JABIRU AIRCRAFT PTY LTD

SERVICE BULLETIN: JSB 012-8

Issue: 8

Subject: Jabiru Engine Flywheel Attachment

Figure 2 - Plain washers compared to Nordloc washers

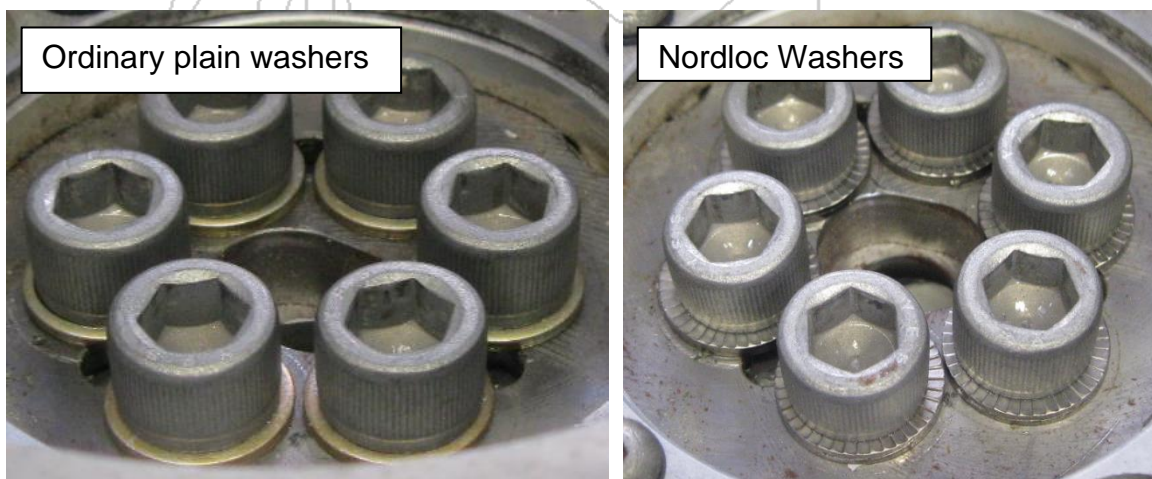
Flywheel screws must now be installed using Nordloc washers (replacing the previous installation which used either plain or Belleville washers). Jabiru engines of any and all flywheel configurations (as defined in Table 1) should now use Nordloc washers. These washers are easily identified via visual inspection as shown below in Figure 2.

Refer to the Jabiru Engine overhaul manual JEM0001 (always check for the latest revision) for the installation procedure of flywheel capscrews using Nordloc washers. The major difference in installation is that bolts installed with Nordloc washers **must not be installed with Loctite**. The torque setting is also different for capscrews installed with these washers.

When Nordloc washers are used on an aluminium surface a steel plate must be used to protect the aluminium surface. These are available from Jabiru.
